2007 IEPR Workshop on Scenario Analysis

Aging Plant Retirements

August 16th, 2007

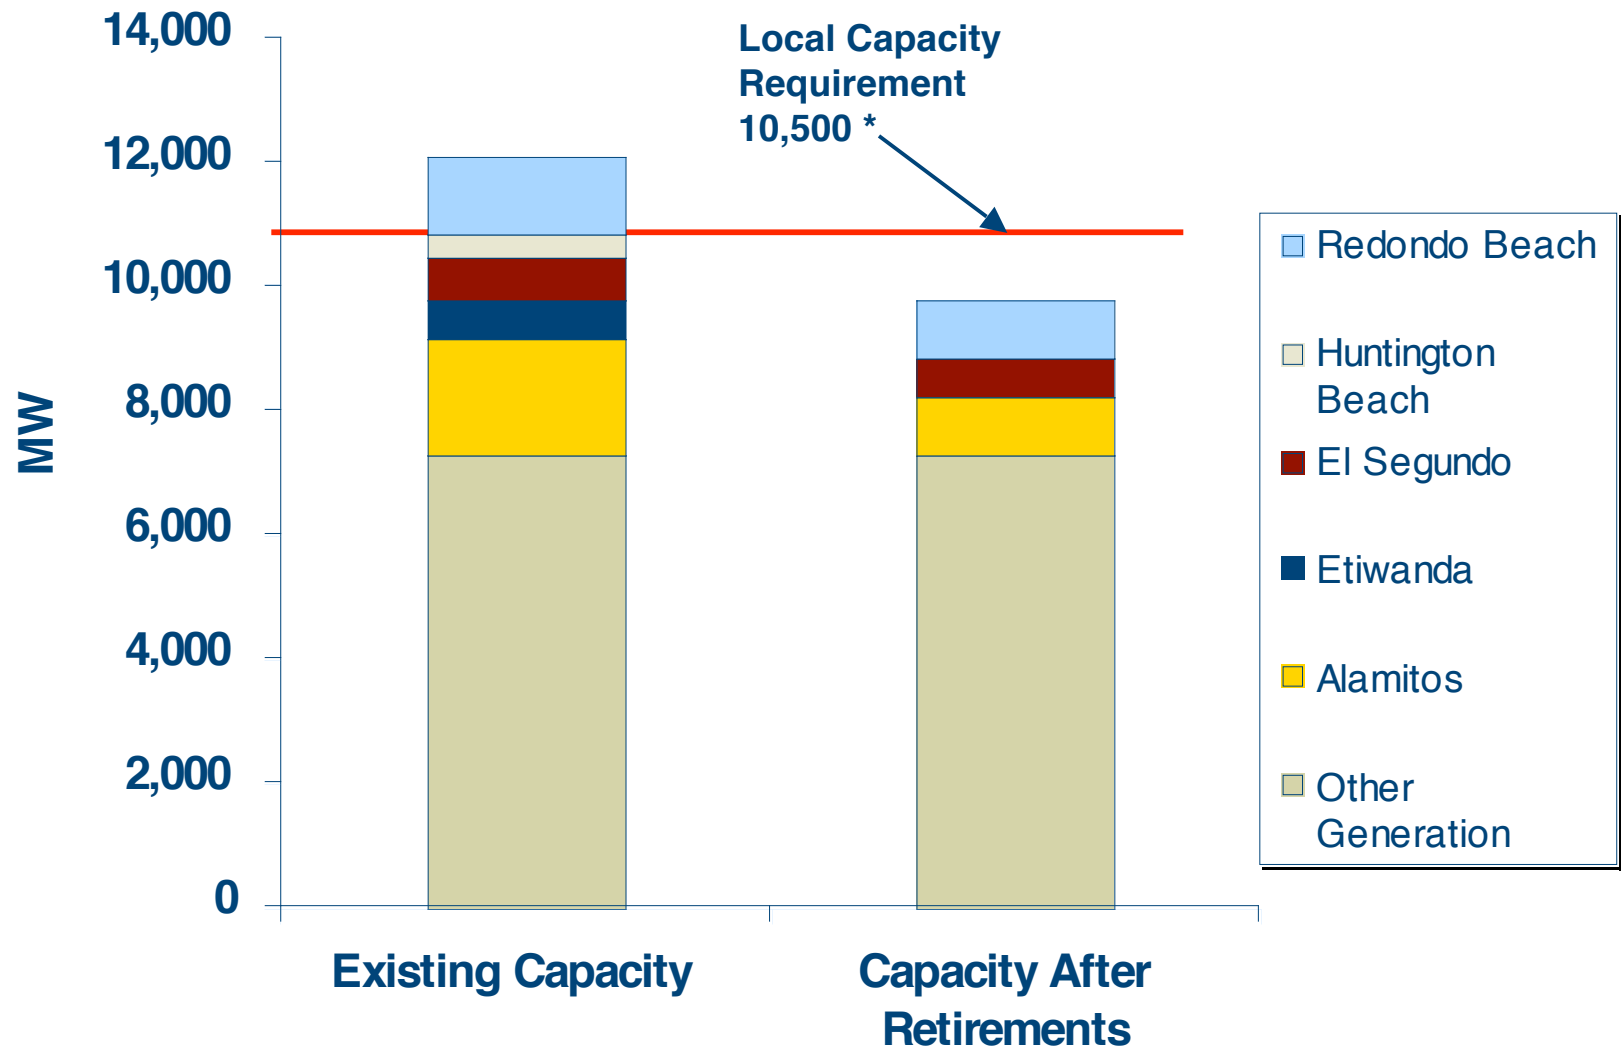
The CEC is investigating the retirement of 4,140 MW of aging fossil fuel plants in SCE's western LA Basin

- ◆ SCE applauds the CEC for its considerable efforts in performing this study
 - It is a reasonable electrical simulation of the SCE power grid
- ◆ SCE agrees with the report in its conclusion that further analysis is needed before implementation of the recommendations is considered
 - We don't necessarily agree with the specific retirement conclusions
 - We believe future upgrades will be more extensive and costly than proposed
- ◆ SCE would like to discuss its view of the current recommendations, this analysis, and any future analysis

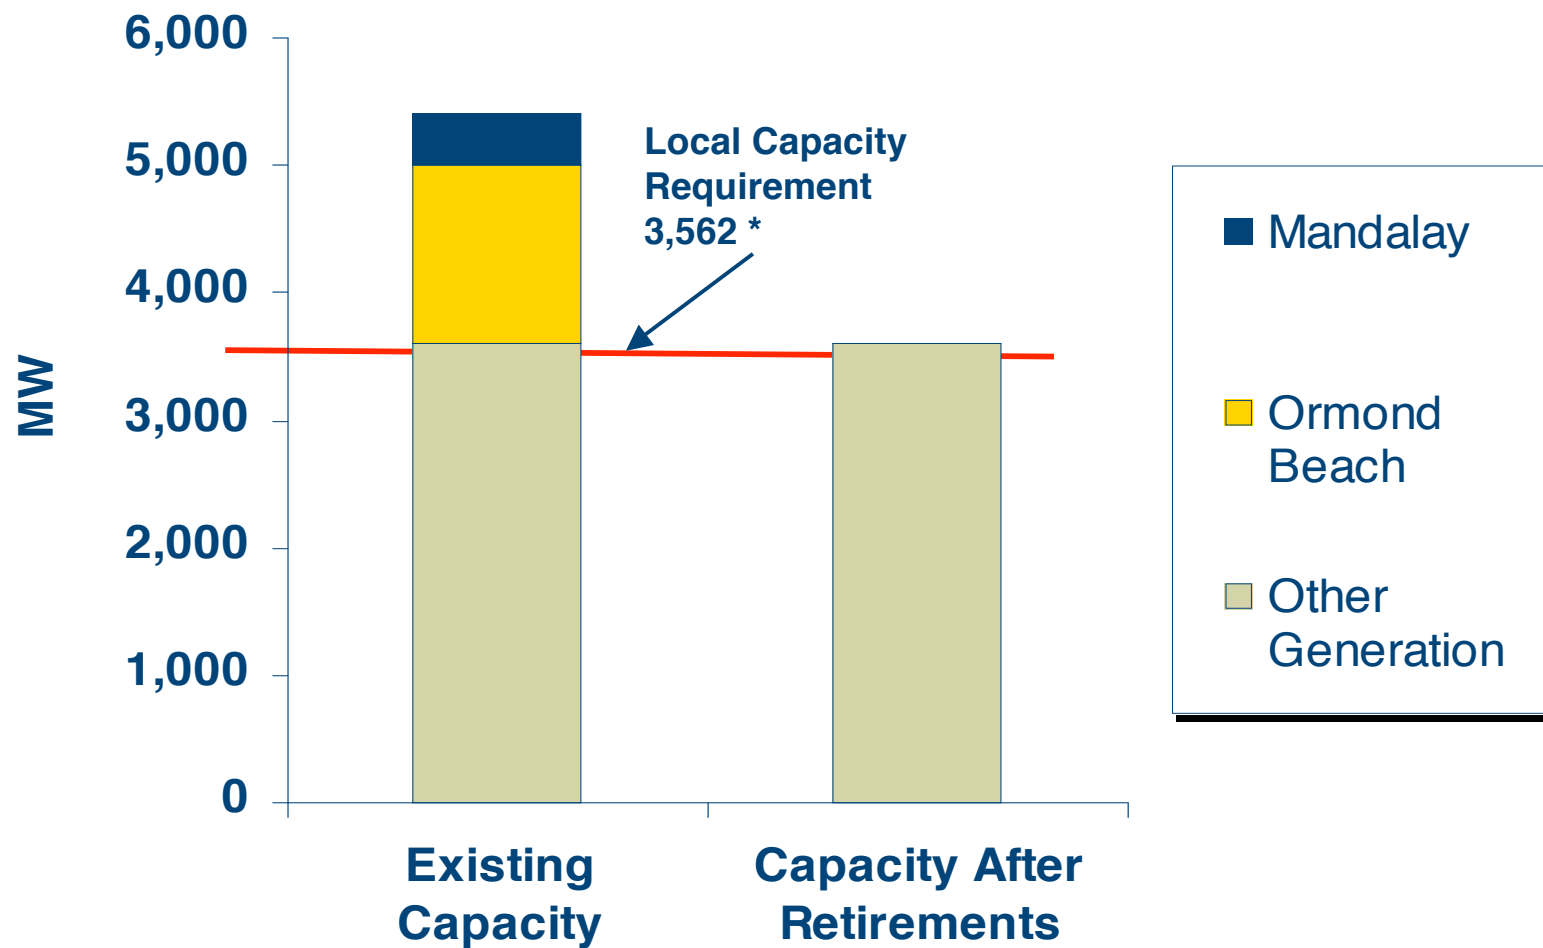
If the plants are retired by 2012 as proposed, there may not be enough capacity in the LA Basin to meet the local capacity requirement (LCR)

If the plants are retired by 2012 as proposed, any future increase in the LCR for the Big-Creek Ventura area may exceed available capacity
